**REVIEW OF THE NIOSH SITE PROFILE FOR
BROOKHAVEN NATIONAL LABORATORY**

Contract No. 200-2009-28555
Task Order No. 1
SCA-TR-SP2009-0001

September 2009

Neutron Flux vs. Neutron Energy in the BNL workplace

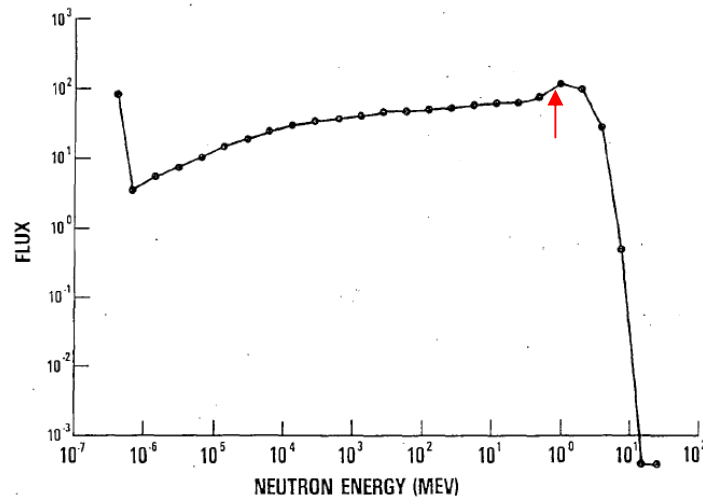
Another example is shown in Figure 7 of G. Riel's 1995 article (Riel 1995, pg. 10), where it can be seen that a large portion of the neutron flux lies below the 0.5–1.0 MeV NTA threshold (red arrow) in the BNL workplace.

The site profile does not specifically address the subject of NTA film threshold. Section 6.4.1, page 91, contains a paragraph of general neutron dosimetry information. Section 6.7, page 94, lists recommended allotment of neutron energies, i.e., 0.1–2.0 MeV and 2–14 MeV, and states that NTA film was used through 1995. Bias and uncertainty values are listed for NTA film in Table 6-7 on page 97 with neutron uncertainty factors listed as 1.35 or 1.5, with a footnote that they are due to lack of knowledge of energy and geometry. The only mention made of the origin of these factors is on page 96, where there is a somewhat unclear statement concerning the fact that the values were taken from the Atomic International TBD (what SC&A found on page 12 of that document is a reference to the Hanford Site TBD), and also because of the fact that the adjusted neutron energy values are similar to, and are based on, Y-12 data (ORAUT 2005b). From this, it is unclear exactly where the values were obtained, and there is no supporting evidence to link the BNL neutron energy spectra to the other sites. The lack of details on this issue may lead to a lack of understanding on the part of the dose reconstructor of how to address low-energy neutrons in dose reconstruction. **For example, SC&A found that four out of five final dose reconstruction reports for BNL claimants, completed after the site profile was issued, did not include the neutron adjustment factors of 1.5 or 1.35 for low energy neutrons;** only the ICRP factors of 1.91 or 2.00 were used. The site profile should address this issue and make clear and technically sound recommendations to compensate for the incomplete neutron doses as recorded by NTA film and contained in the dose of record.

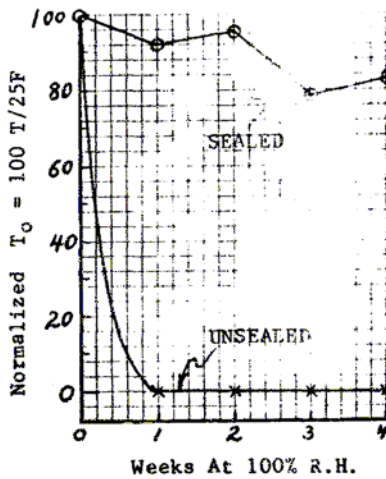
et al. 1973), NTA film was tested in sealed and unsealed packages. The unsealed NTA film lost all tracks in only 1 week at 100% relative humidity (RH), as shown in the following plot:

Percent of original tracks vs. time

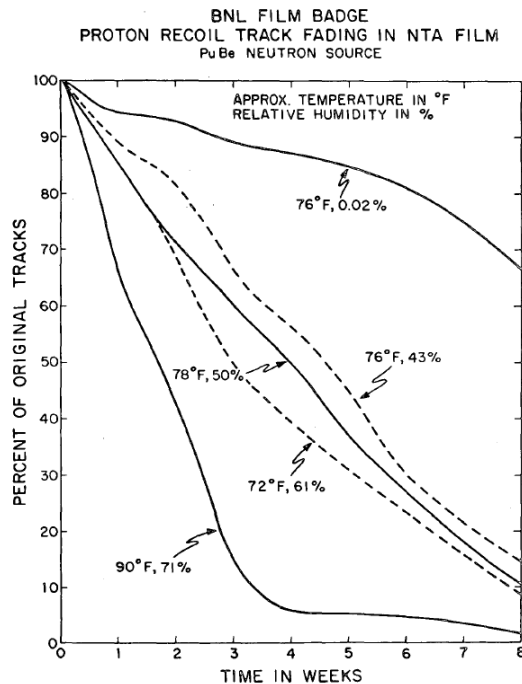
Another 1974 article by L. Phillips (Phillips 1974, pg. 18) describes tests run at BNL to determine NTA track fading. The results, using a relatively high-energy PuBe neutron source, are shown in the following plot.

Percent of tracks remaining after t_0 vs. weeks stored at 100% RH

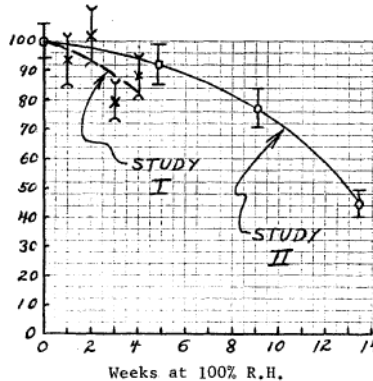
A 1975 article by L. Phillips describes a test in which two different types of packets were used to seal NTA films. The sealed NTA films were then exposed to neutrons and stored at 100% RH. The percent of the original tracks remaining (compared to the number at t_0) as a function of time is summarized in the following plot.
